Staff Report
Range USA
660 James L. Hart Parkway
Stage II Planned Development Final Site Plan Review

We have completed the second detailed engineering review of the plans dated January 11, 2022, with a latest revision date of February 24, 2022, and stamped received by OHM Advisors on February 28, 2022.

RE: Detailed Engineering Review #2
Project Name: Range USA
Project Location: 660 James L. Hart Parkway Ypsilanti, MI 48197
Plan Date: 10/19/2021
Revised Plan Date: 2/24/2022
Project Job Number: 168921002
Applicable Codes: IFC 2018
Engineer: Kimley - Horn of Michigan, Inc.
Engineer Address: 39111 Six Mile Road Livonia, MI 48152

Re: Detailed Engineering Review #2
Shoot Point Blank
Charter Township of Ypsilanti (Plan Date: 02-24-2022)

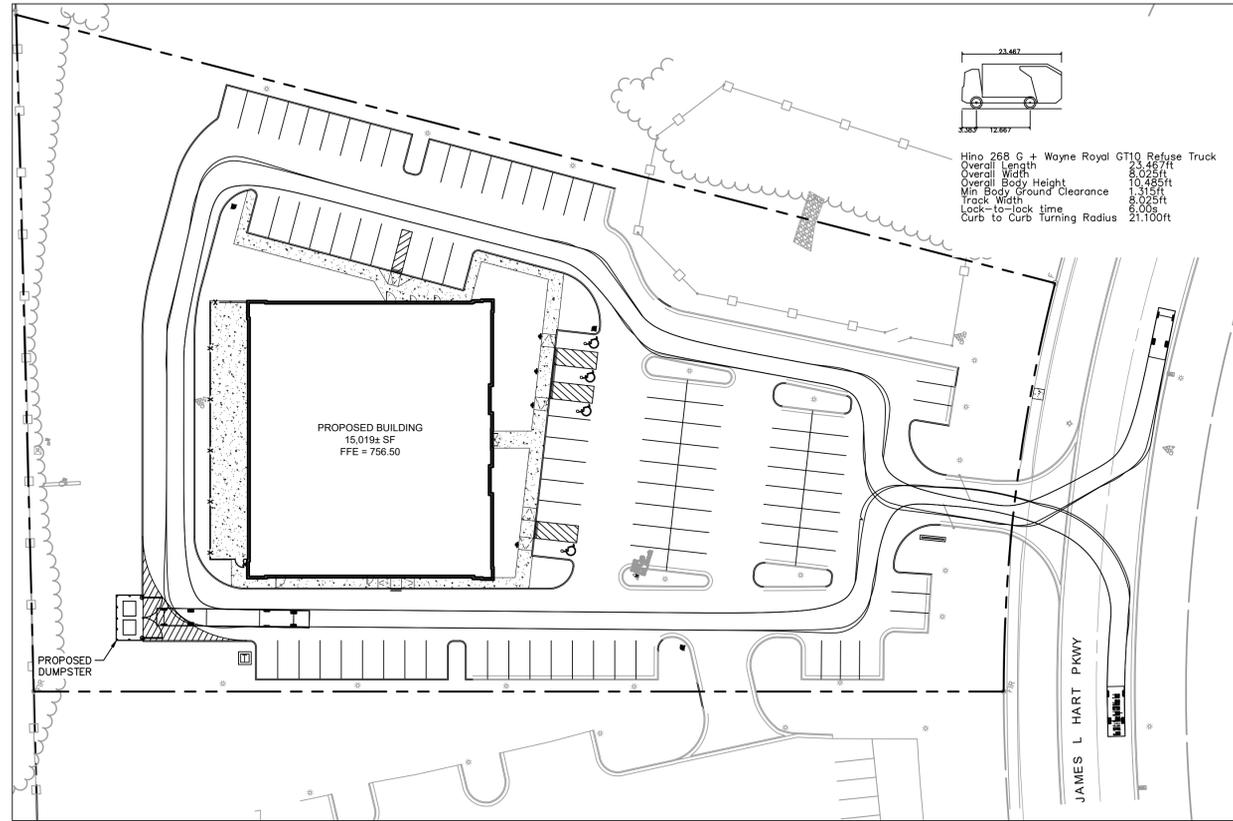
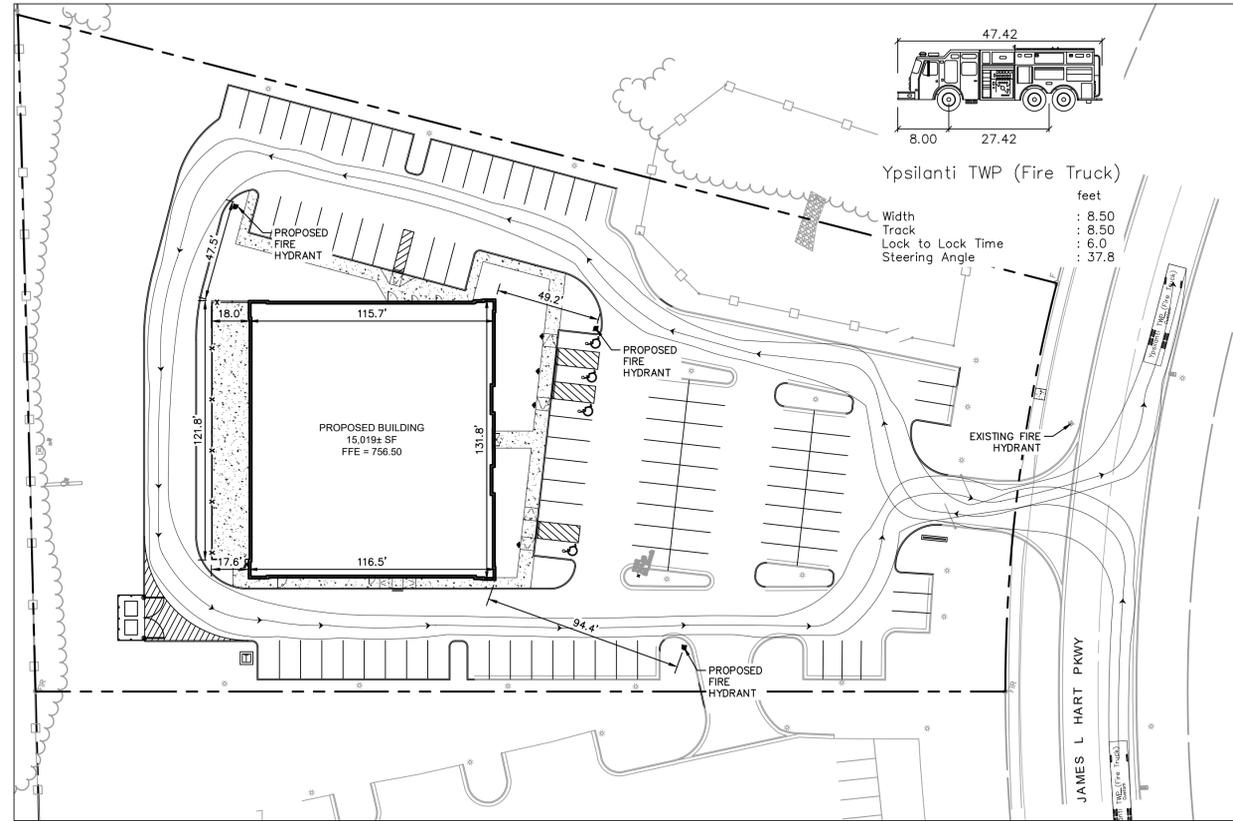
12. The applicant shall include all pavement, sidewalk, and curb and gutter details within the plan set. It currently appears there is no detail for the depressed curb and gutter called out on sheet C3.0. **The applicant has sufficiently addressed the comment.**
13. The applicant shall provide the spot elevations at all four corners of proposed barrier-free parking space, access aisle, ramps, and level landings, as well as at 50-foot intervals along all sidewalks to ensure ADA compliance. The applicant shall note that the cross slope shall not exceed 2%. **The applicant has addressed the comment, but it appears that there are three ramps shown at the maximum 8.33% running slope. We recommend lowering this slope to ensure ADA compliance is met during construction.**

GRADING PLAN	
RANGE USA 660 JAMES L. HART PARKWAY YPSILANTI TOWNSHIP, MI	
ORIGINAL ISSUE:	10/19/2021
KHA PROJECT NO.	168921002
SHEET NUMBER	C5.0

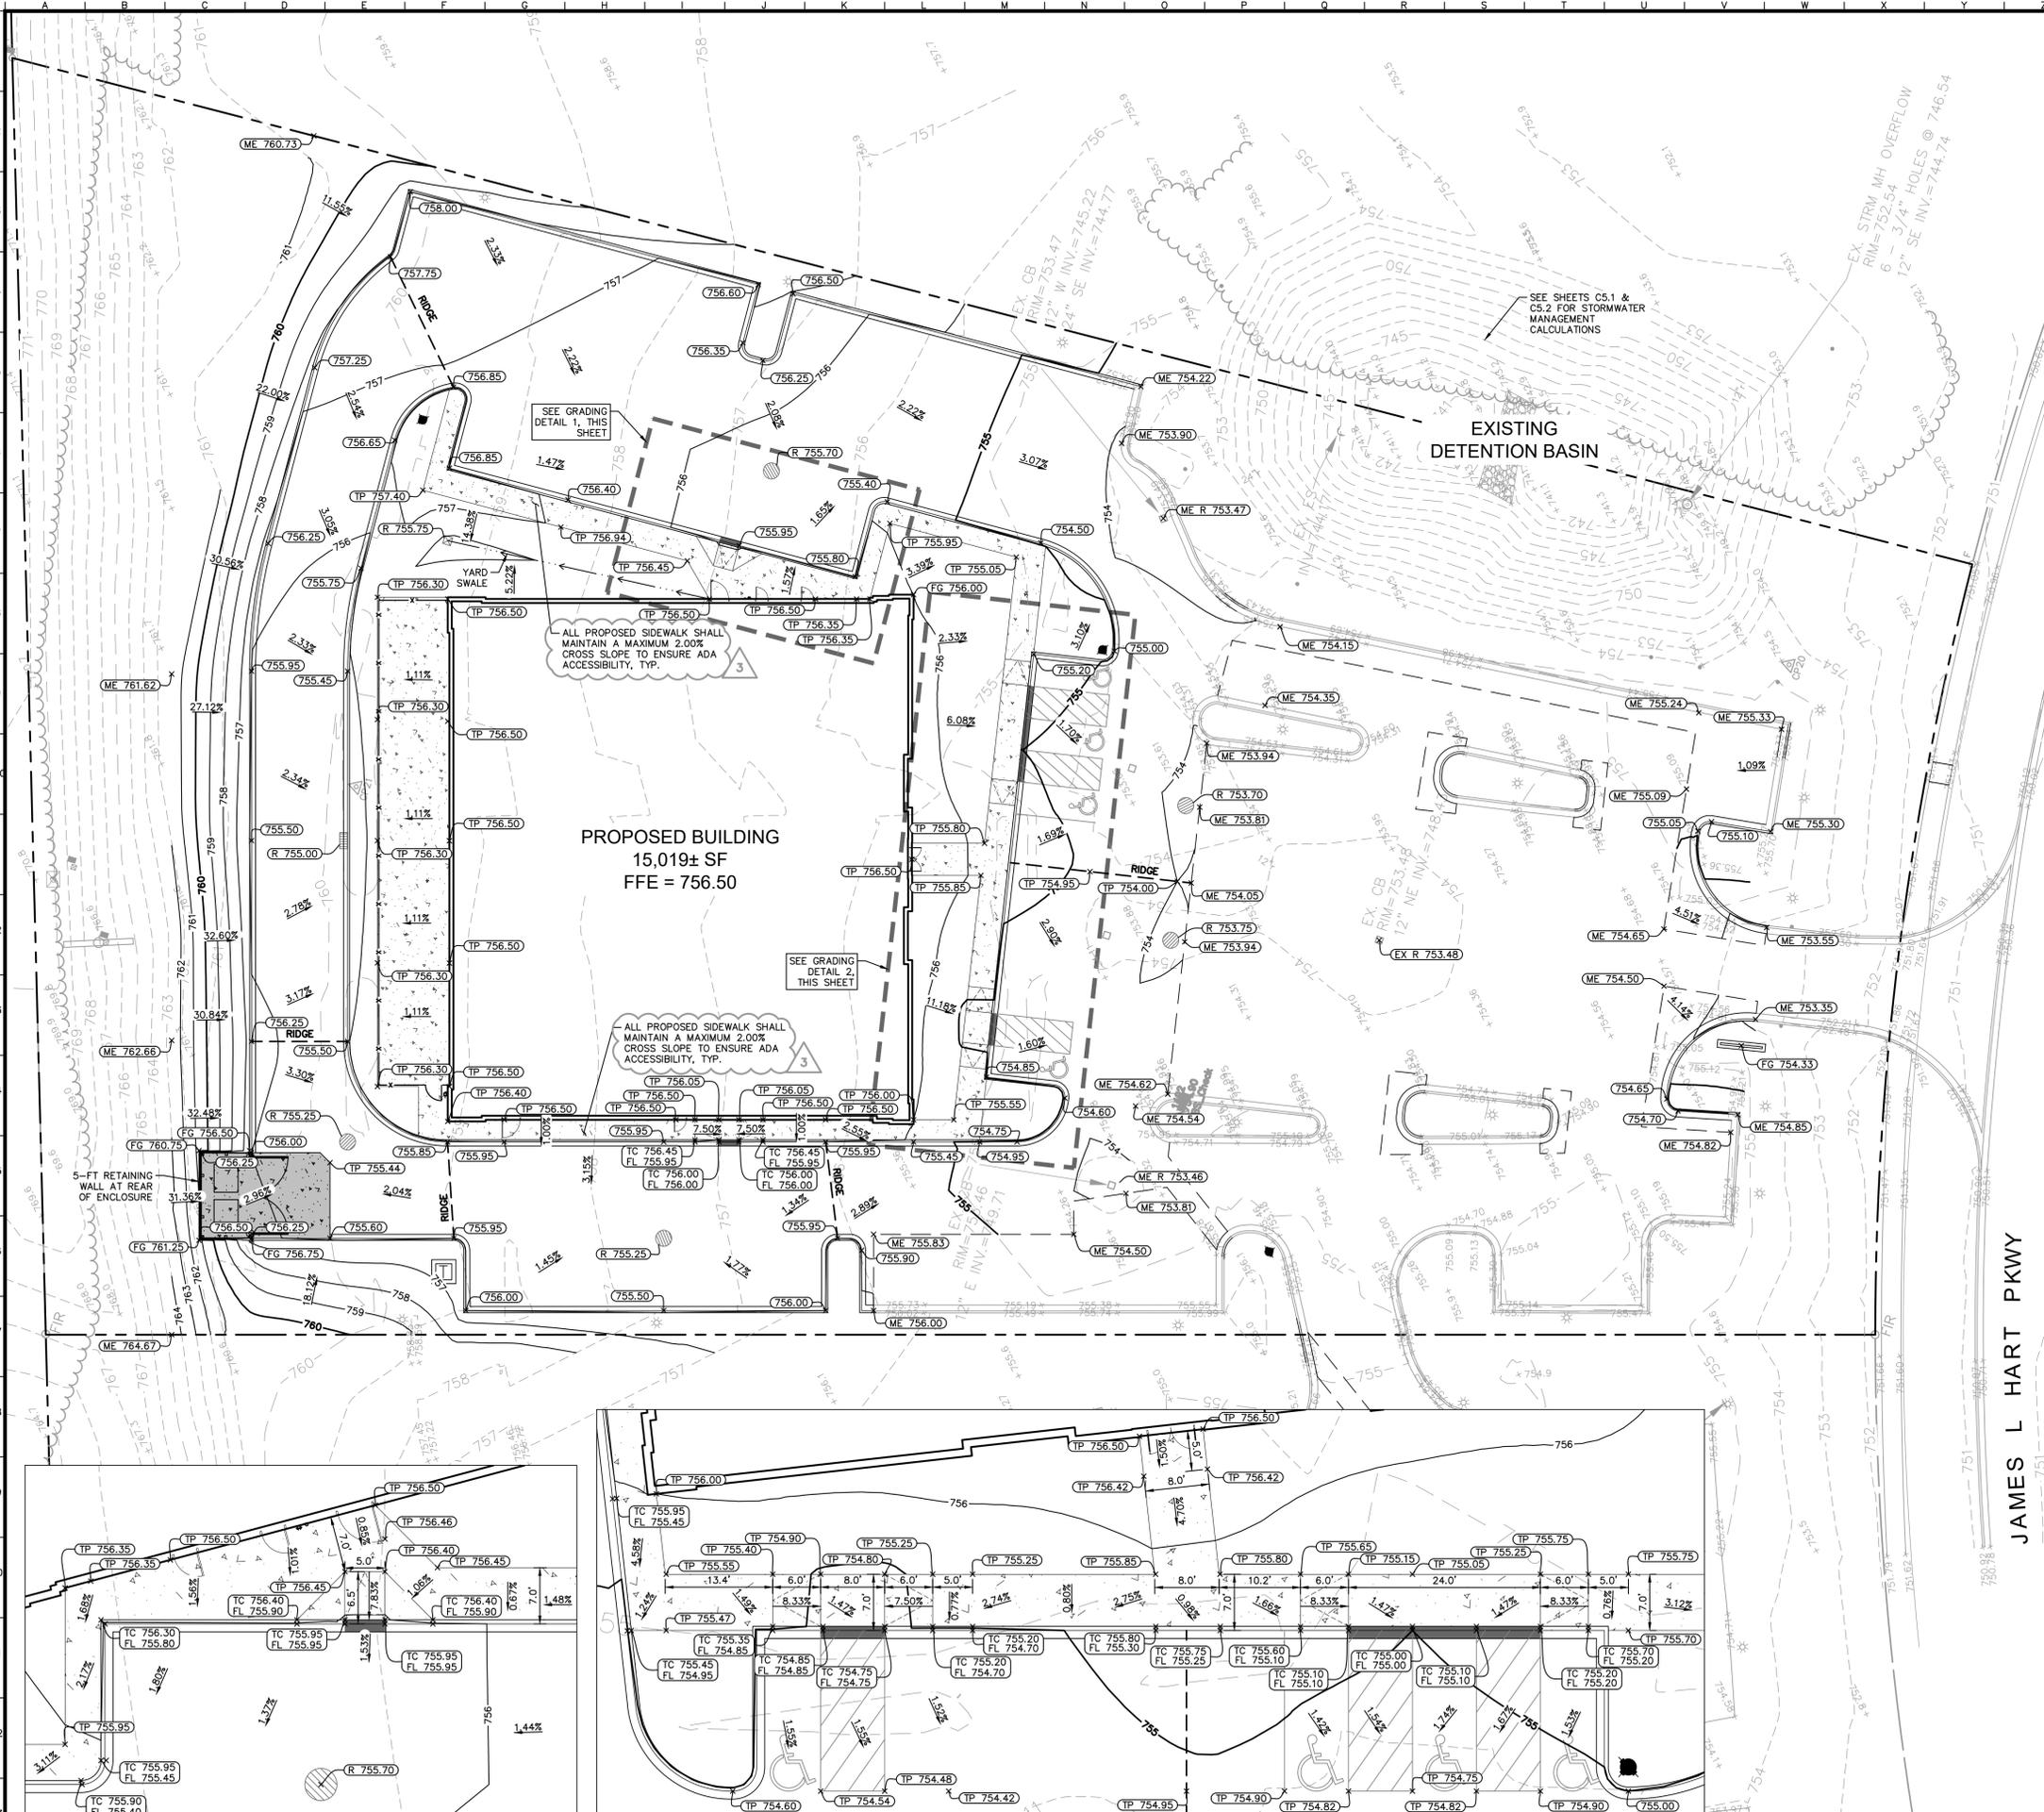
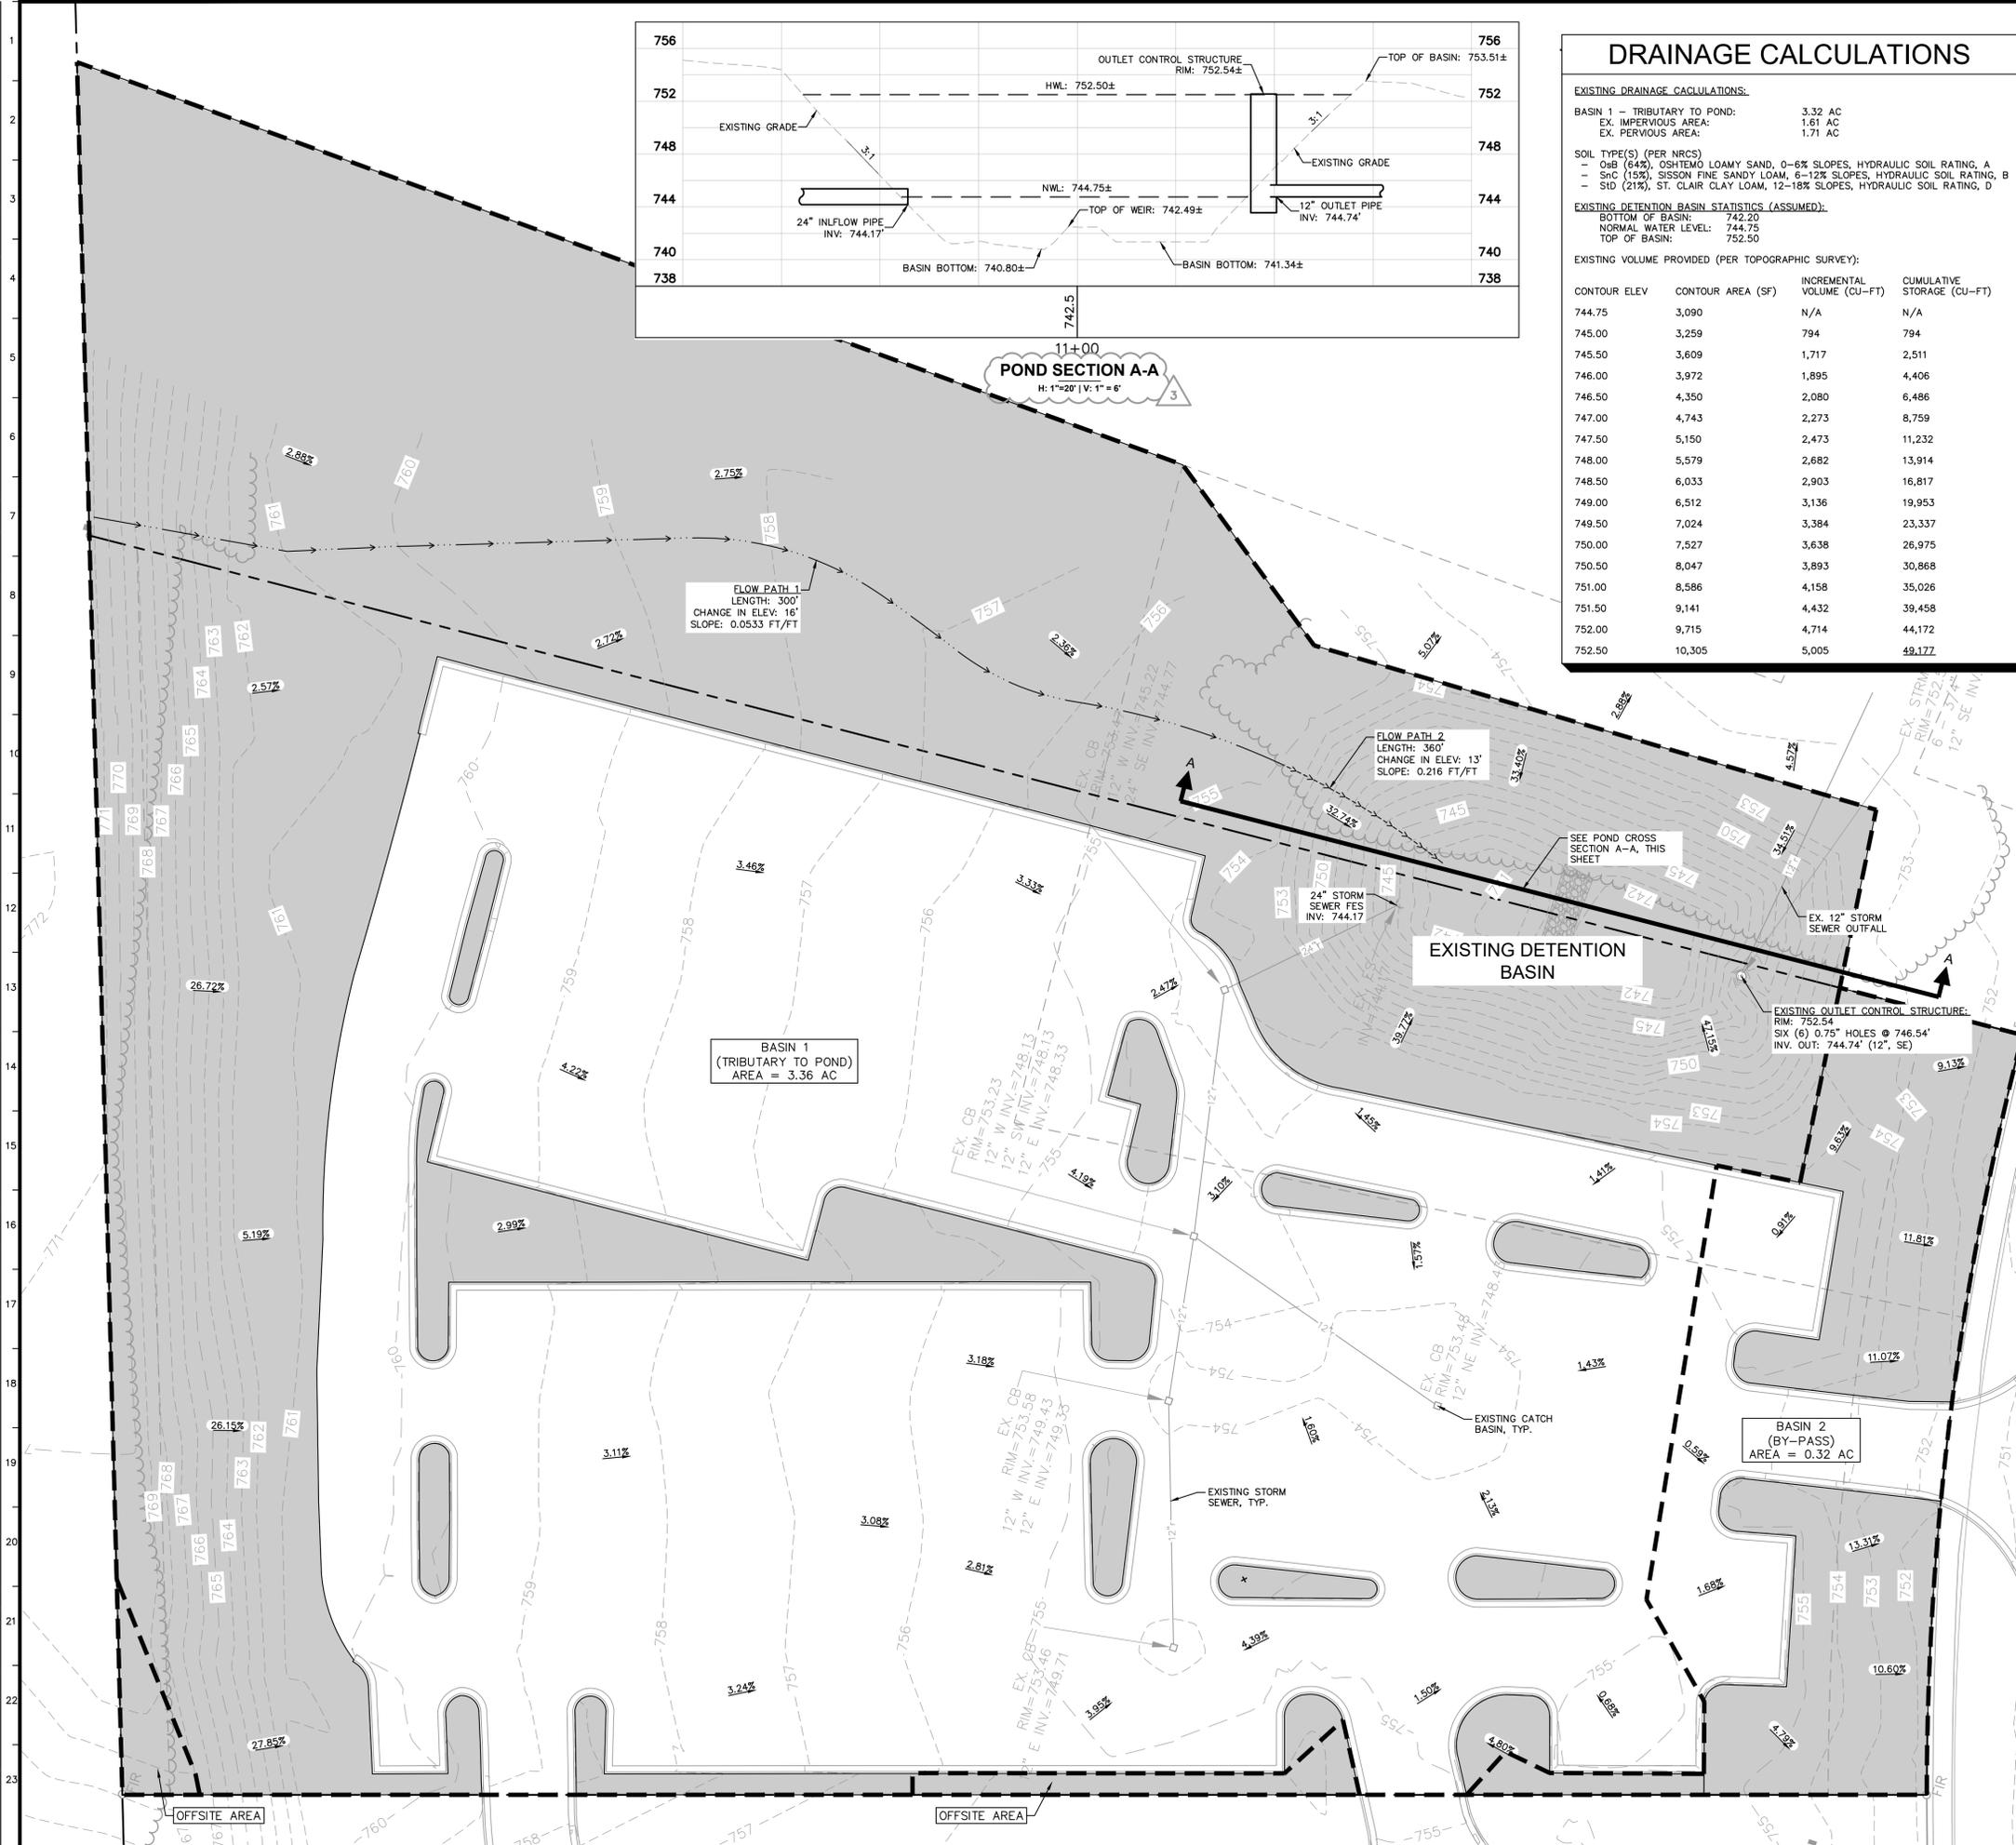
6. The applicant shall revise the C-value listed for drainage area D9 on the plan view on Sheet C5.3 as there appears to be a discrepancy with the storm sewer summary table. **The applicant has sufficiently addressed the comment.**

STORM SEWER PROFILES

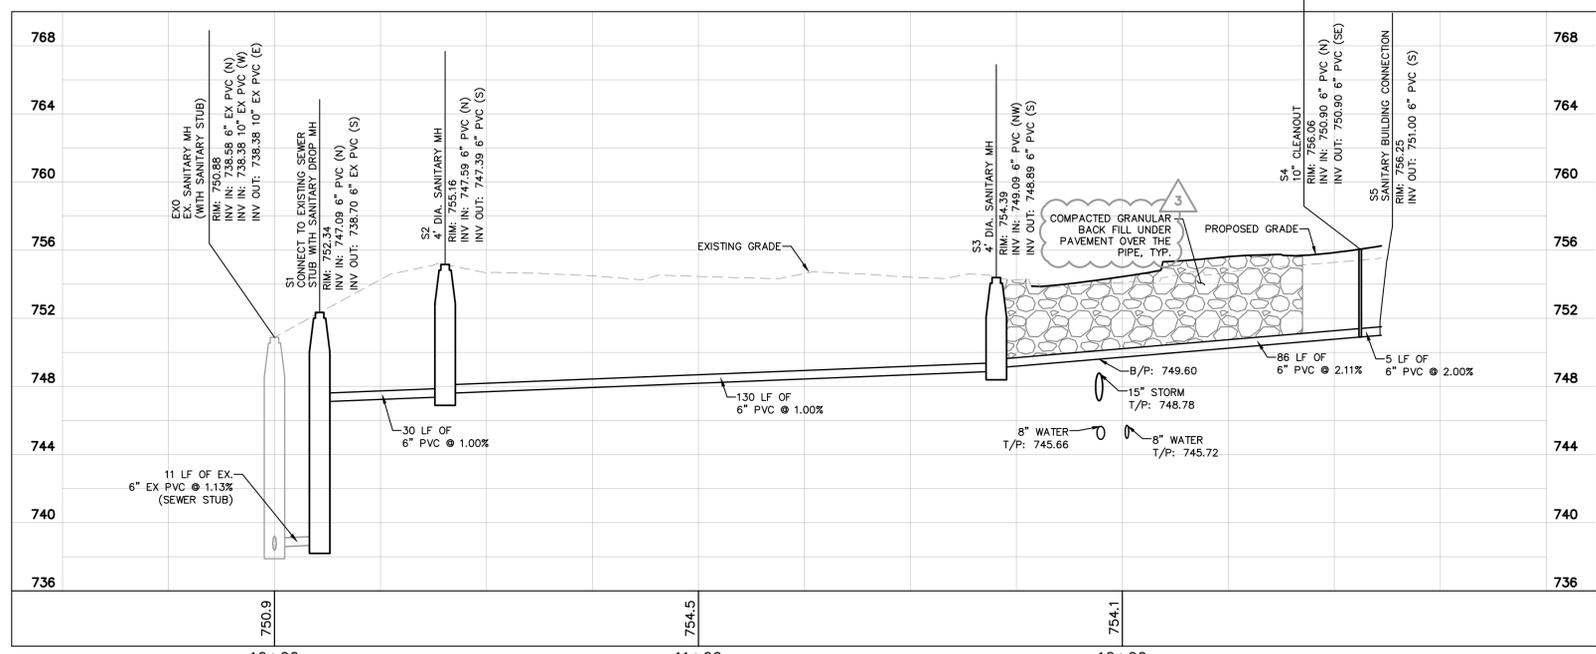
11. The applicant shall provide a profile view of the connection to the existing structure (storm line EX2 to D4).
